Re: Final Report
Groundwater Budget and Approach to a Groundwater Management Plan,
Upper and Lower Ventura River Basin

Groundwater Budget and Approach to a Groundwater Management Plan Upper and Lower Ventura River Basin

Response to Comments

DRAFT Groundwater Budget and Approach to a Groundwater Management Plan, Upper and Lower Ventura River Basin (75% Complete), dated August 20, 2010

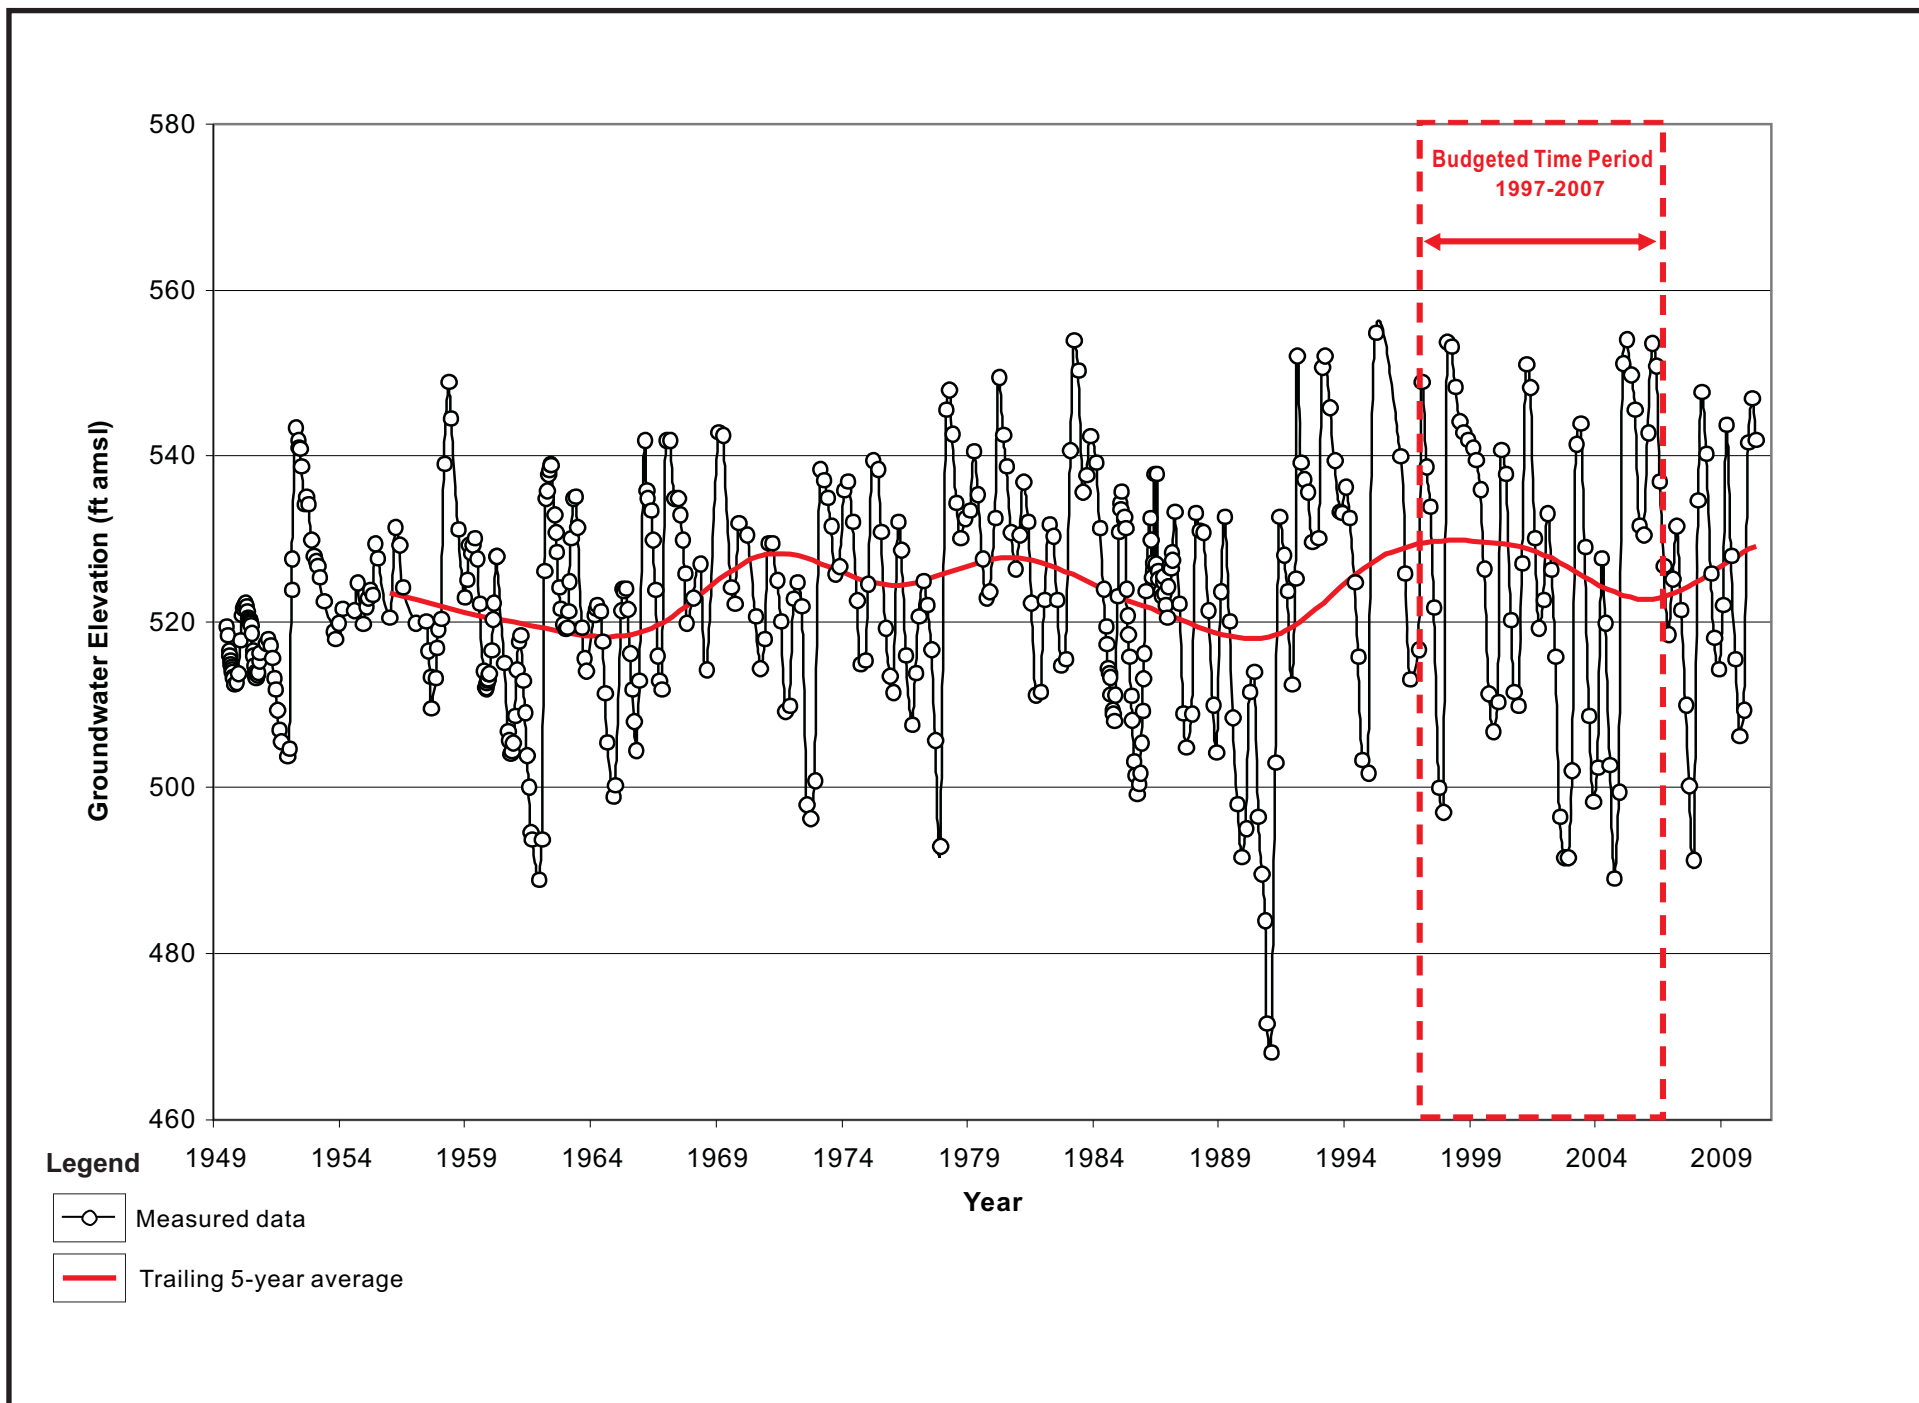
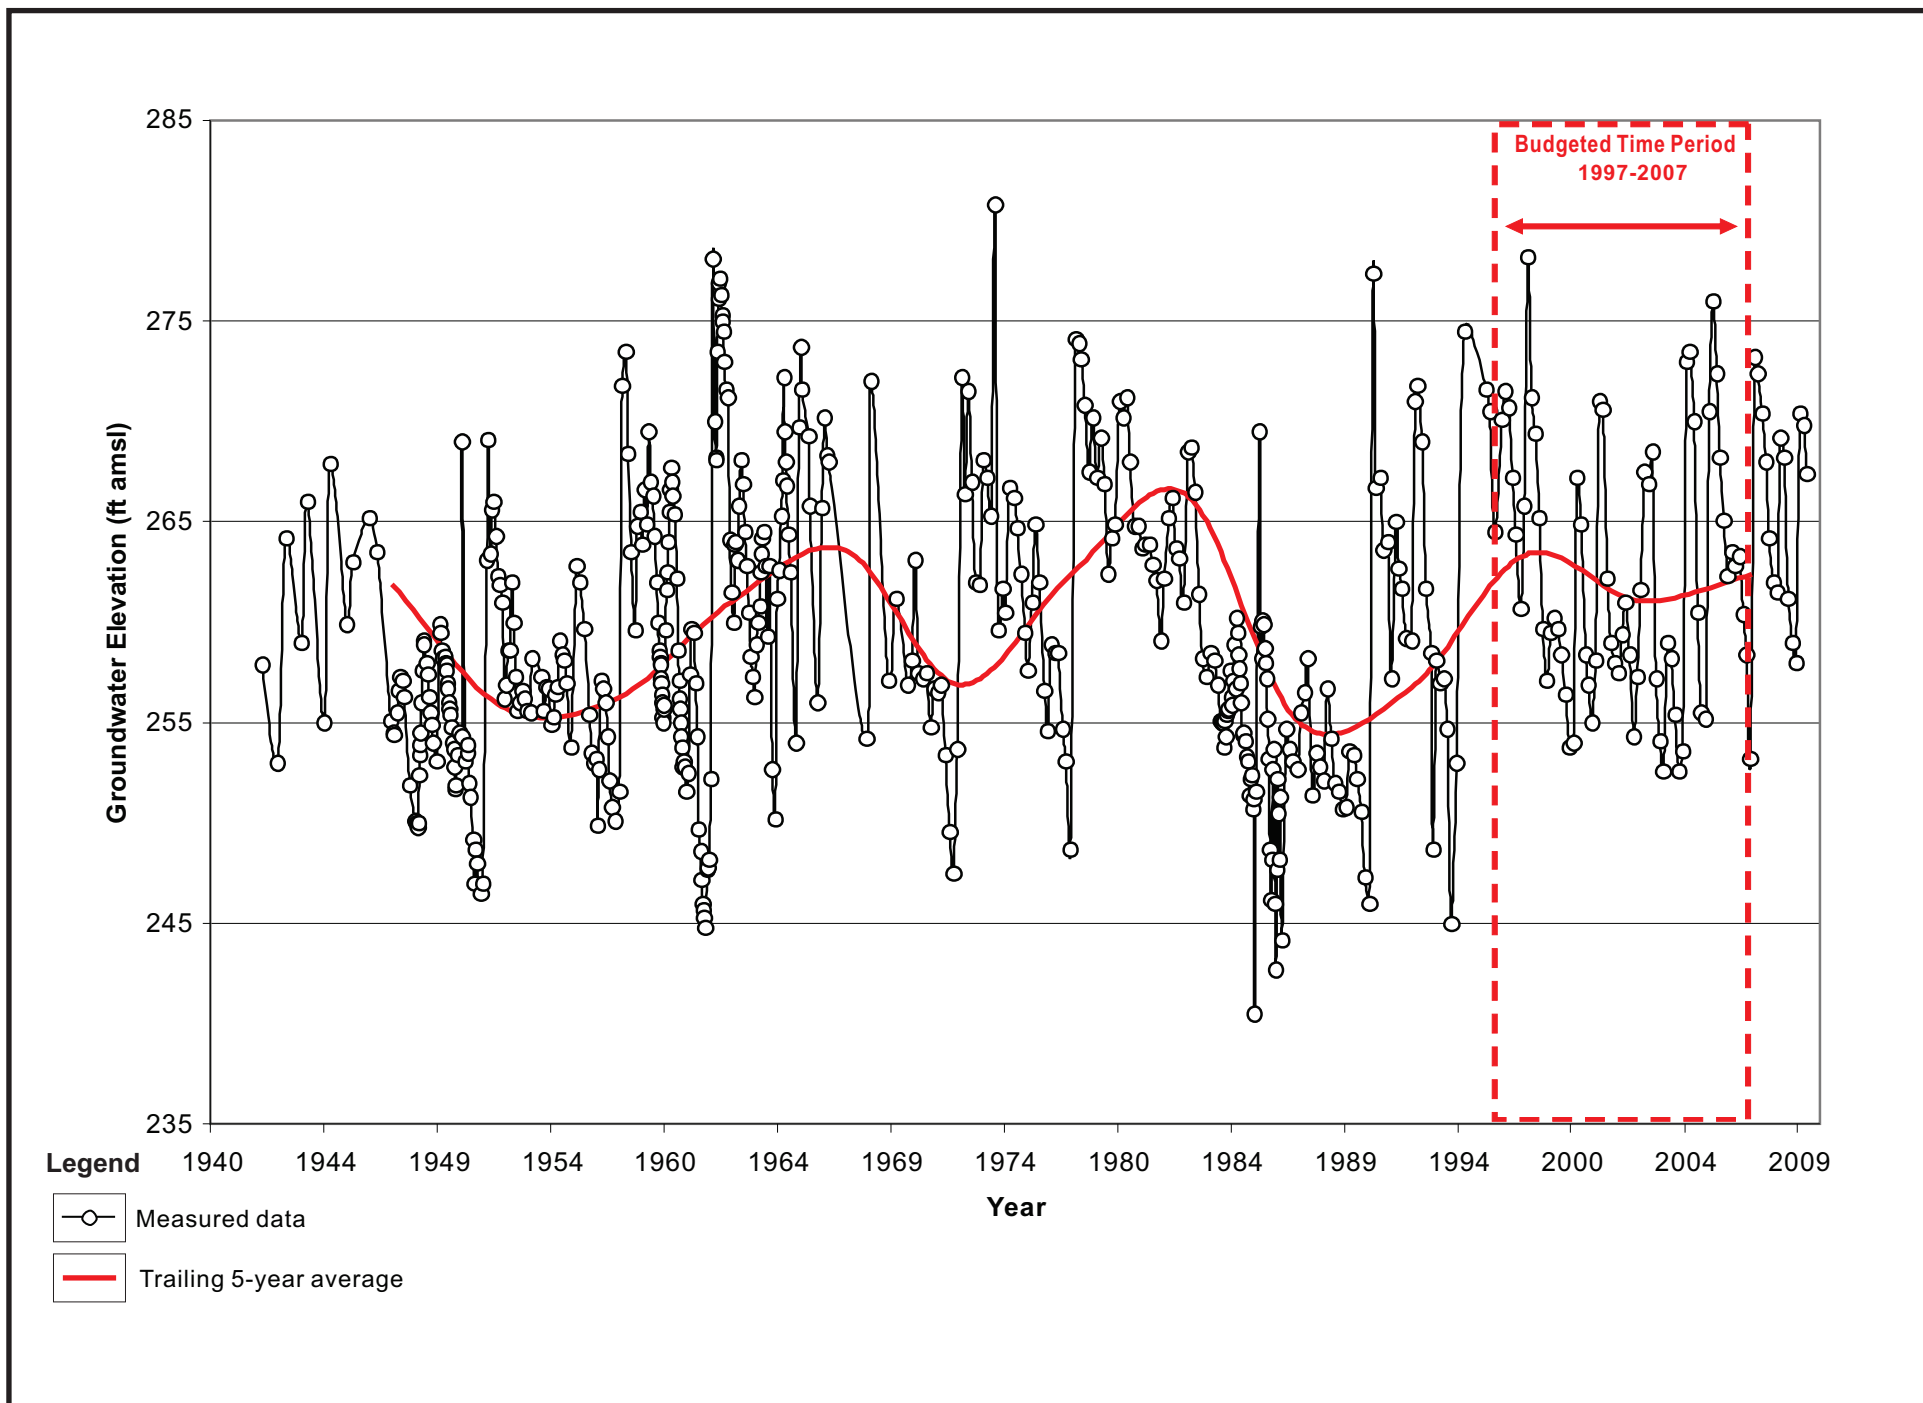
26. *Figure 2 - Figure 2 is used to support the concept that overall water levels have remained stable in the basin, but one of the concluding tables in the report shows a net deficit of around 2000 acre feet per year. This appears internally inconsistent. Please include an explanation.*

The discussion regarding comparison of hydrographs and the results of the budget has been revised.

Figure 6: Isohyets of Annual Average Precipitation (inches). Annual average precipitation data are shown relative to the locations of the Subbasins. [Sources: Annual Rain Contours, 1997-2007, used in Tetra Tech, 2009; Subbasin boundaries from Tetra Tech, 2009]

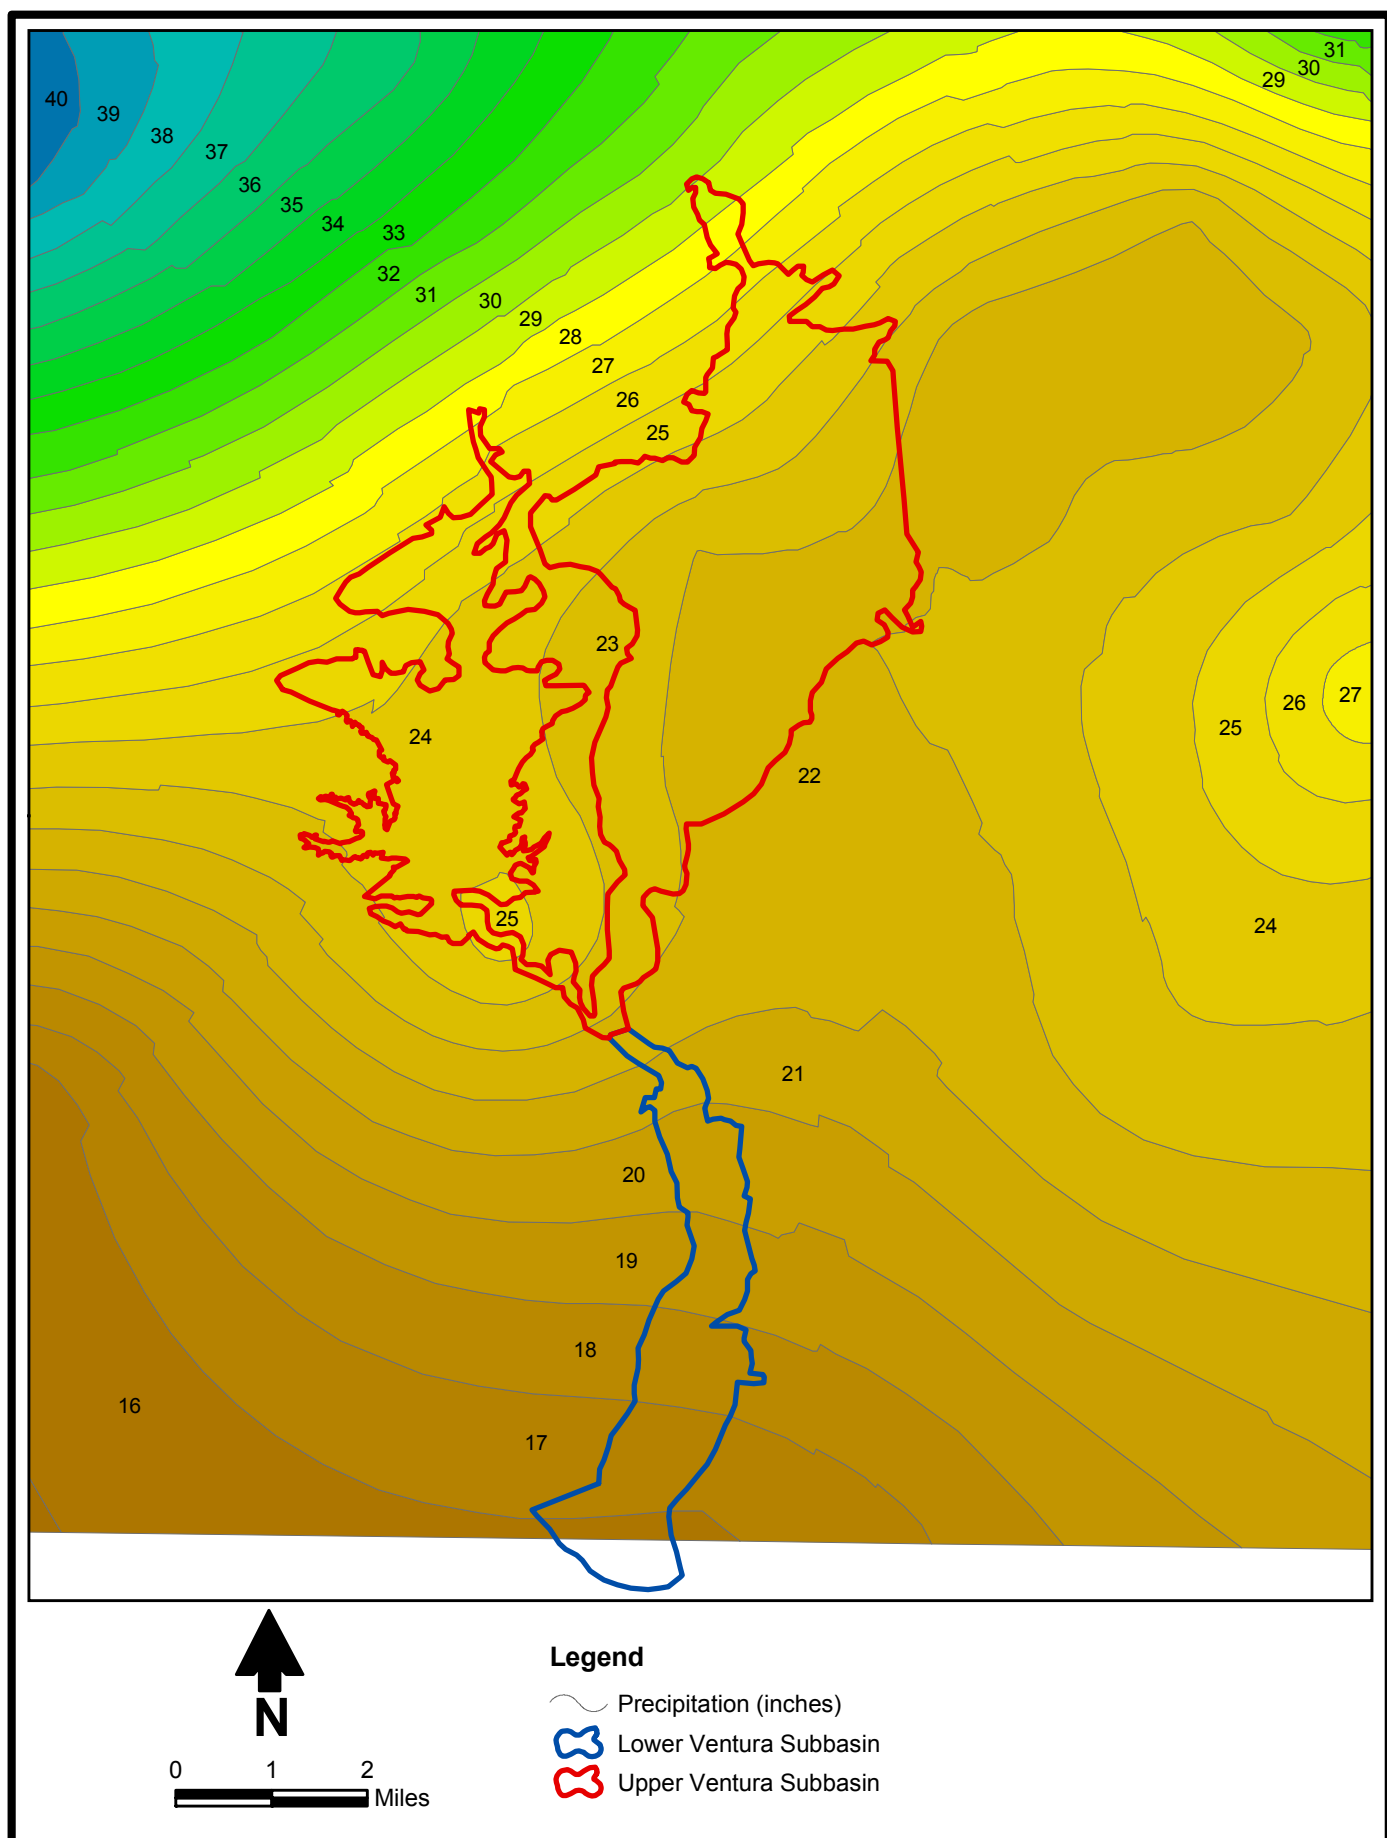
27. *Figure 4 - Please indicate the time period used for determining average rainfall shown by Figure 4. Please include the units for rainfall measurement. This could be included in a caption. Explanation of gap between isohyets and edges of basin and watershed boundaries (why colored part does not extend to edges of basin) should be included. (It was already mentioned during DBSA's presentation, but the basin boundaries between Upper and Lower do not meet and should).*

This figure has been edited as requested. The southern tip of the Lower Subbasin is not included in the original figure from Tetra Tech from which this figure was derived, but is assigned a precipitation of 16 in/yr due to the absence of another contour line.
